Access Compliance Report

Public Rights-of-Way

Intersection ID: 9696	Main Street: HERRIN_AV	Cross Street: N_DAVIDSON_ST	Location: SW
ADA ID: FA1B04A3E880	Ramp Type: Perp	Initial Pass/Fail: Fail	Overall Compliance: No
		Severity Score: 12.5

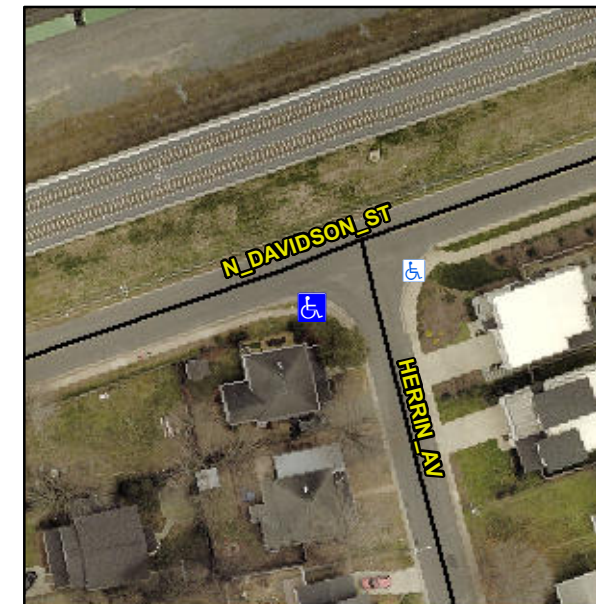
Not Found, R304.2.2

Compliance	Description	Data	Compliance	Description	Data
N/A	Ramp Length (in)	68.0	No	Ramp Slope (%)	9.1
Yes	Ramp Width (in)	48.0	Yes	Ramp XSlope (%)	0.1
N/A	Flare Type LT	N/A	N/A	Flare Type RT	N/A
N/A	Flare Slope LT (%)	N/A	N/A	Flare Slope RT (%)	N/A
N/A	Flare Traversable LT?	N/A	N/A	Flare Traversable RT?	N/A
N/A	Landing Length (in)	N/A	N/A	DWS Provided?	N/A
N/A	Landing Width (in)	N/A	N/A	DWS Contrast?	N/A
N/A	Landing Slope (%)	N/A	N/A	DWS Length (in)	N/A
N/A	Landing X Slope (%)	N/A	N/A	DWS Full Width?	N/A
N/A	Landing Curb? (Y/N)	N/A	N/A	DWS Offset (in)	N/A
N/A	Shared Landing?	N/A			
N/A	Gutter Ponding?	N/A	N/A	Gutter Slope (%)	N/A
N/A	Gutter Lip Ht (in)	N/A	N/A	Gutter X Slope (%)	N/A
N/A	Painted X Walk1?	No	N/A	Painted X Walk2?	N/A
	X Walk 1 Direction	To E		X Walk 2 Direction	N/A
N/A	X Walk 1 Width (in)	N/A	N/A	X Walk 2 Width (in)	N/A
	X Walk 1 Slope (%)	2.7		X Walk 2 Slope (%)	N/A
	X Walk 1 X Slope (%)	0.9		X Walk 2 X Slope (%)	N/A

Remove & Replace Entire Ramp.
